Mantrust Sweater Ltd

Vogra, Chandana, Gazipur

20 May 2014

Observations

Tested ground floor column – brick aggregate

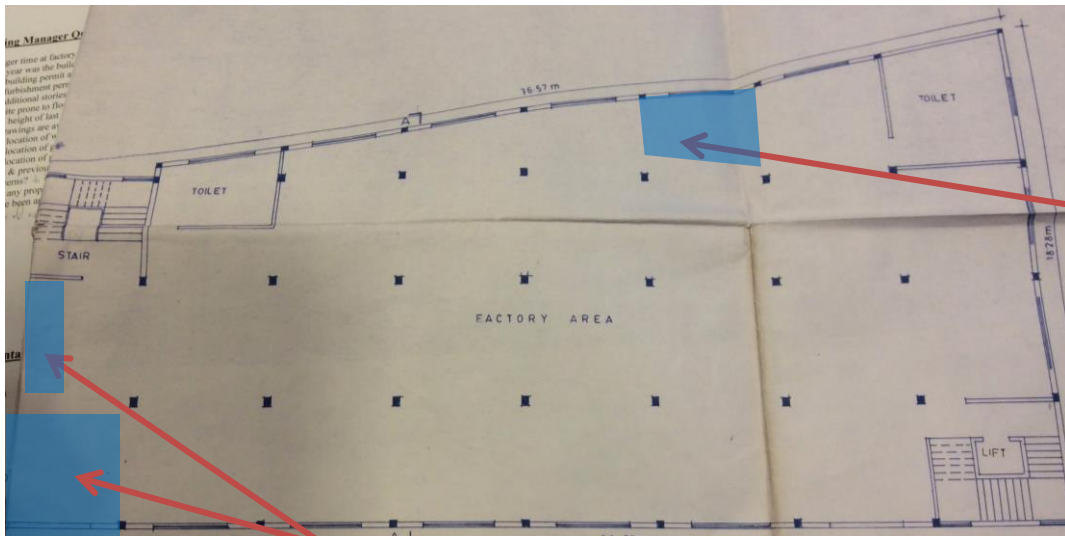
Small column sizes leading to high column stresses

Due to the small column sizes and the high number of storeys the column stresses are generally high for all columns.

Detail Engineering Assessment and immediate load reductions required.

High storage loads

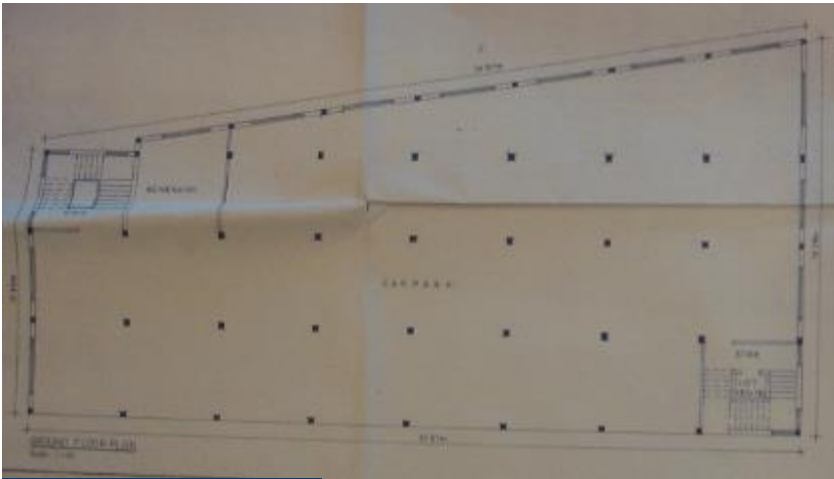
High storage loads in some areas

Building Engineer to create controlled loading plans for all floors which will designate where storage can be placed.

Permit drawing

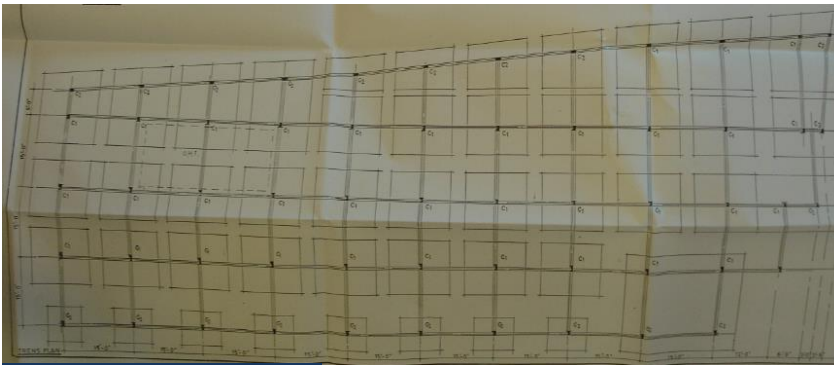
The building permit for commercial use was given by LGED only in July 2011 when the building was already completed up to the 5th floor. It is unclear what the written restriction on the permit drawing “only layout plan approved” means.

The structural drawings are from May 2014 when the whole building was already built. They are inconsistent with the permit drawing with regards to the building geometry in several areas.
